<b>Subject:</b>  REDUCTION OF TIE-DOWN PLUGS - SERVICE TIP	<b>Bulletin No:</b> 00-001/05
	<b>Last Issued:</b> 3/14/2005

2005 RX-8 (April 1, 2005 production and later)

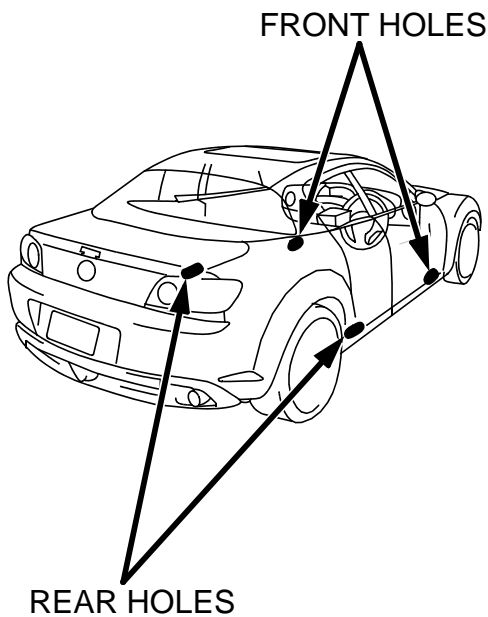
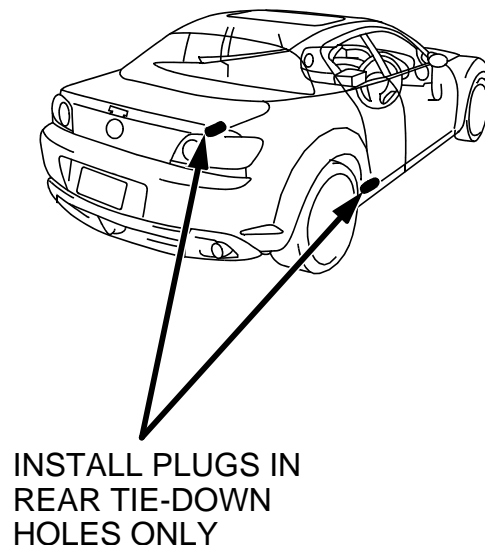
Beginning with April 1, 2005 production, only 2 plugs will be in the glove box. Please fit these 2 plugs to the rear side tie-down holes only, leaving the front 2 tie-down holes open. Revised instructions will be included with the 2 tie-down plugs.
